KEYSTONE XL PIPELINE PROJECT

0515-SD-P4-346.6-347.2-S

KEYSTONE XL PROJECT
PROPOSED ROUTE VARIATION

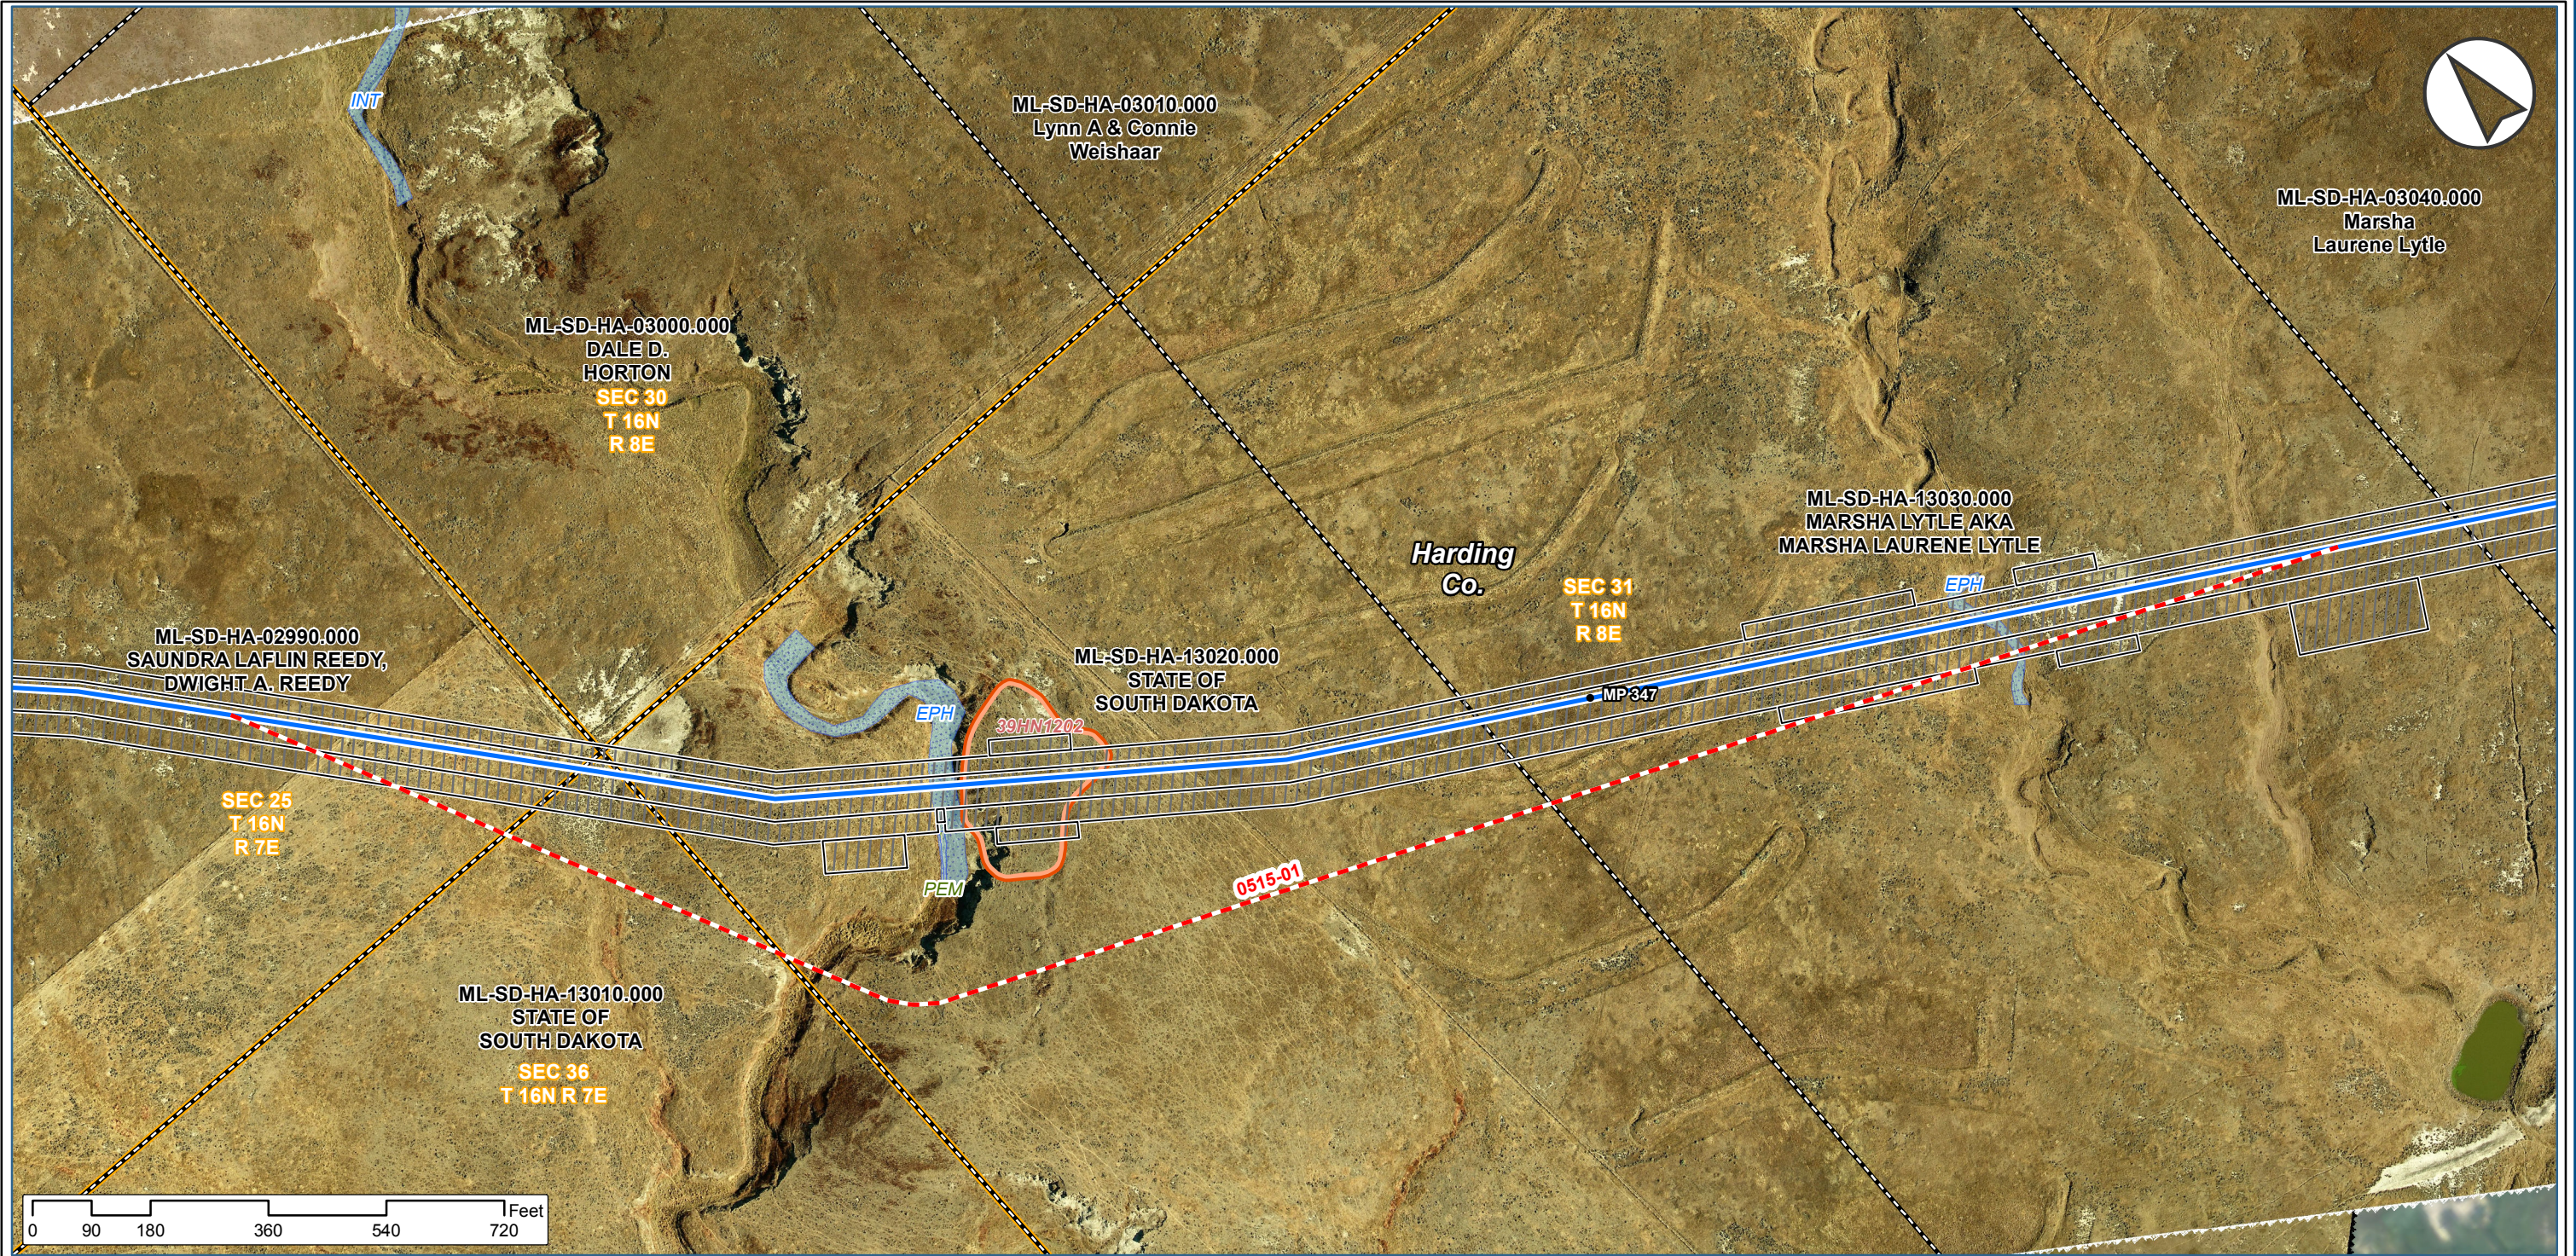
3	REASON FOR ROUTE VARIATION (Please include reason for route variation):		
	<p>The primary reason for this route variation is to avoid impacting eligible pehistoric cultural site (SN # 39HN1202 or C710HA009) by shifting the CL/workspaces southwest, thus avoiding the need for treatment/mitigation measures.</p> <p>This reroute is requested by Environmental and has been verified by field reconnaissance (civil survey).</p>		
	DETAIL ROUTE VARIATION (Please describe route variation in detail):		
	<p>The proposed route variation begins near MP 346.6 and deviates ~15° west from the current CL and continues for ~1,093 ft before rounding into a 2,246 ft. stretch where it connects back to the CL near MP 347.2.</p> <p>5 Tracts impacted: ML-SD-HA-02990.000 (Dwight A. and Sandra Laffin Reedy) ML-SD-HA-03000.000 (Dale D. Horton) - To be offline ML-SD-HA-13010.000 (State of South Dakota) ML-SD-HA-13020.000 (State of South Dakota) ML-SD-HA-13030.000 (Marsha Lytle)</p>
